BN/19/18/PL

PLAN-022990

Proposal: Erection of 1 No. dwelling & separate single storey double garage.
This application is a Departure from the Development Plan.
Site: The Cottage, Piggeries, Church Lane, Barnham, PO22 0DB.
BN/19/18/PL

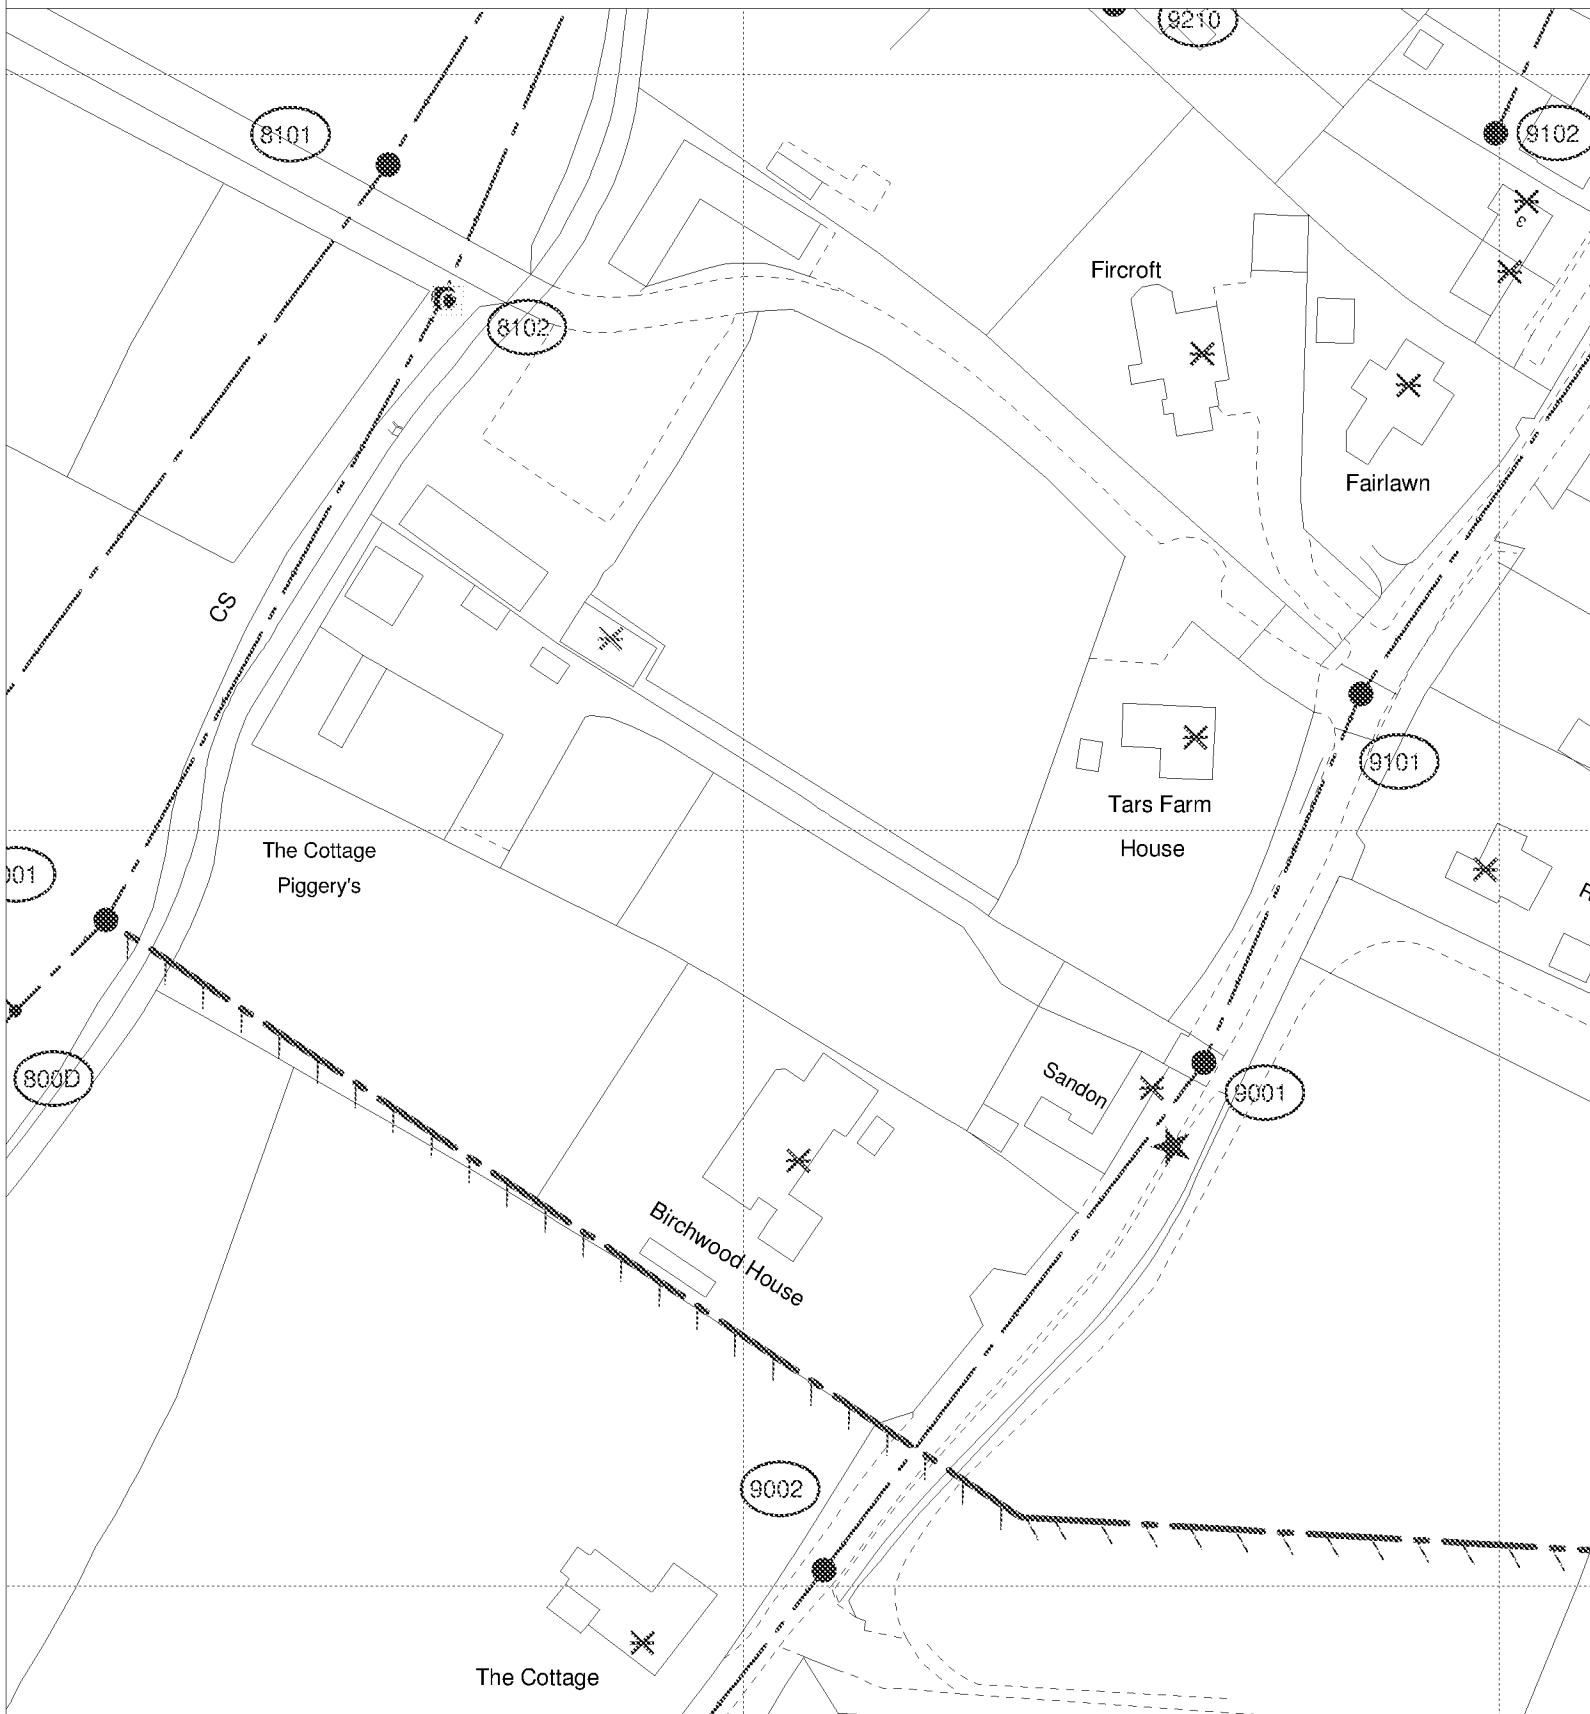
Due to surface water inundation issues in the Lidsey Catchment "The applicant is advised to adopt, where appropriate, the measures in the table "Practical measures to reduce the potential impacts of development".

Developer should look to protect the public sewerage system from inundation and infiltration, which contribute to flooding in unfavourable conditions.
